APPLICATION NO.	FILING DATE	FIRST NAMED INVENTOR	ATTORNEY DOCKET NO.	CONFIRMATION NO.
10/683,725	10/09/2003	Jeffrey A. Roberts	RobertsBoomStand	1628

Office Action Summary	Application No. 10/683,725	Applicant(s) ROBERTS ET AL.	
	Examiner Korie H. Chan	Art Unit 3632

DETAILED ACTION

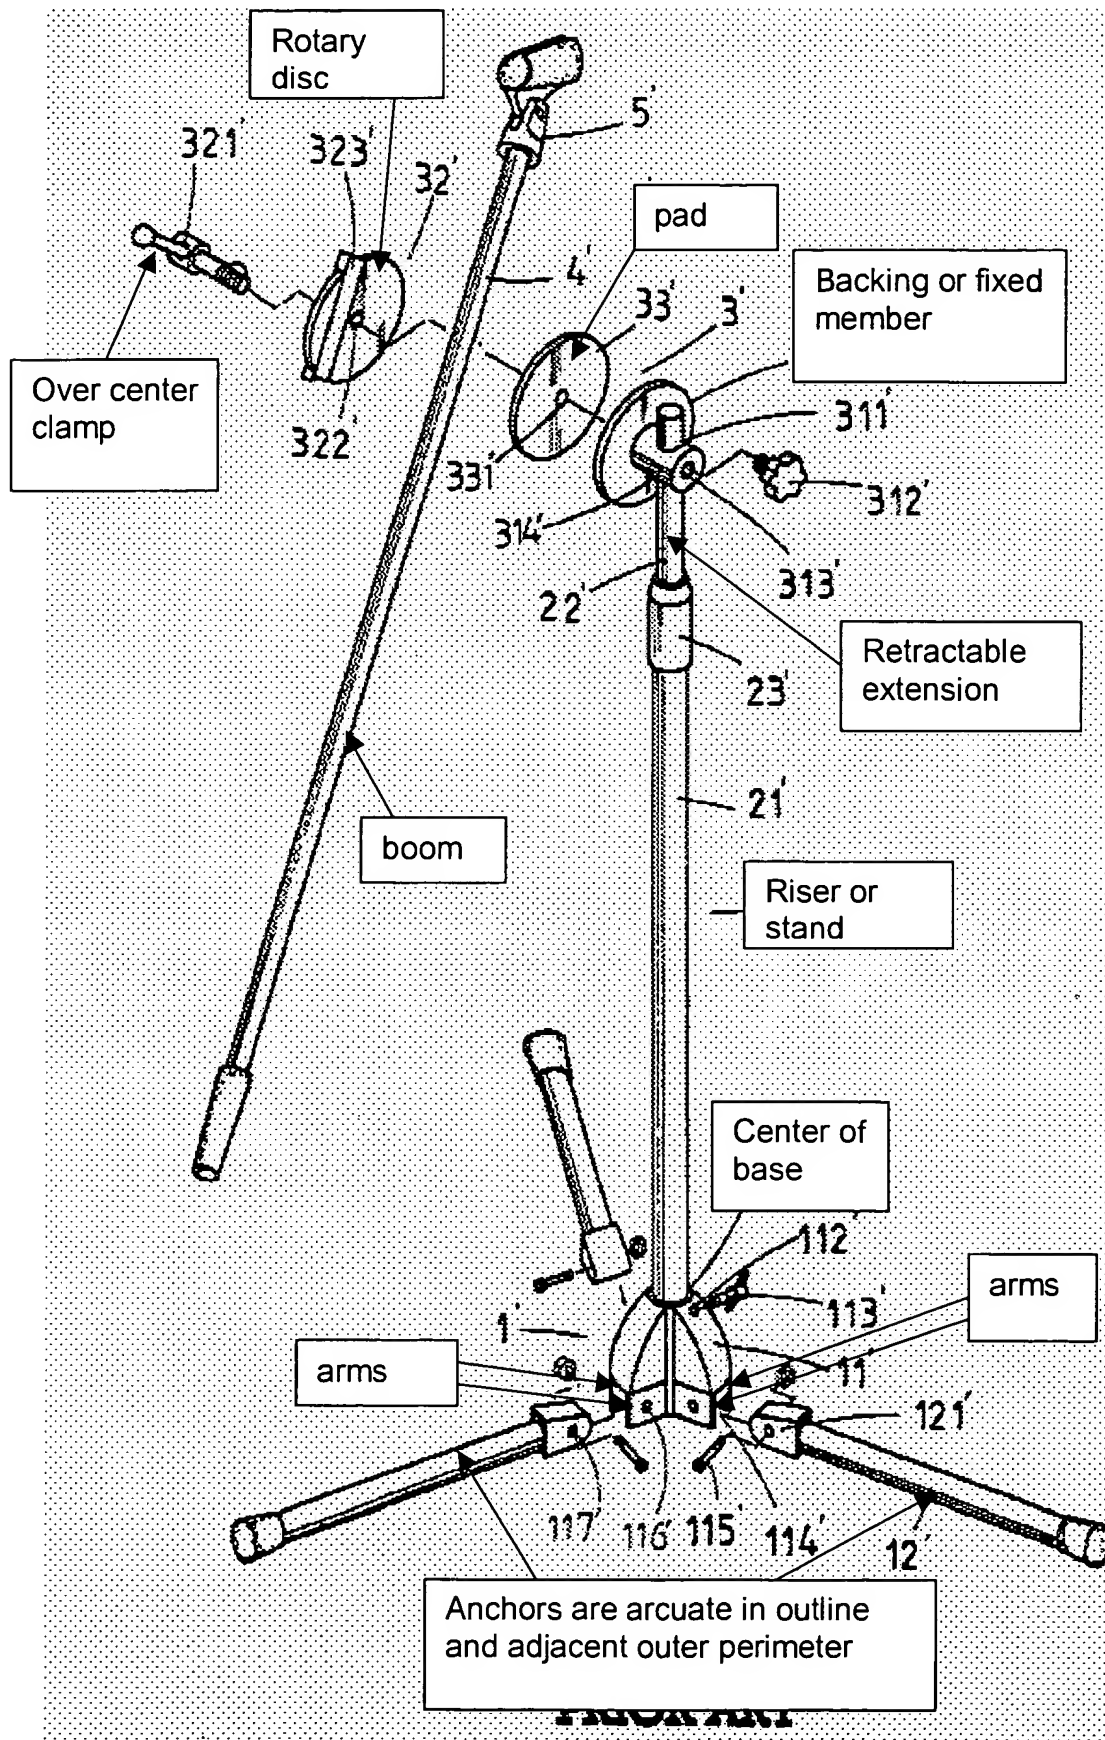
Claims 9-13 and 19-22 are rejected under 35 U.S.C. 102(b) as being anticipated by Prior Art (figures 8-10) disclosed by Kuo (US patent no. 6,007,032). The Prior art in Kuo discloses all the claimed features of applicant's claimed invention (see the following

examiner's illustration). Further, regarding claims 13, Kuo's prior art discloses the anchor (12', figure 8) is sized to be capable of fitting within the space between the anchors and has a maximum dimension (length of 12') larger than a distance between the adjacent anchors.

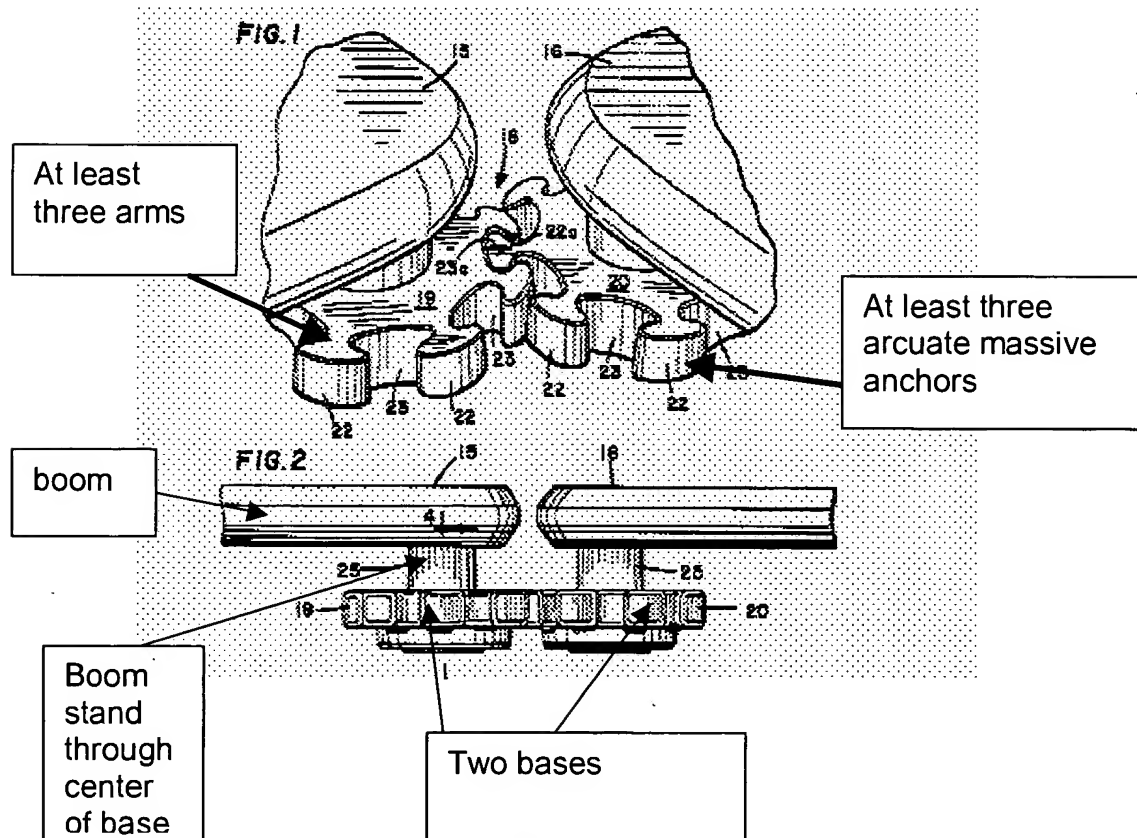
Claims 9-16 are rejected under 35 U.S.C. 102(b) as being anticipated by Barrett et al (US patent no. 6,182,580). Barrett discloses all the claimed features of applicant's invention as illustrated below.
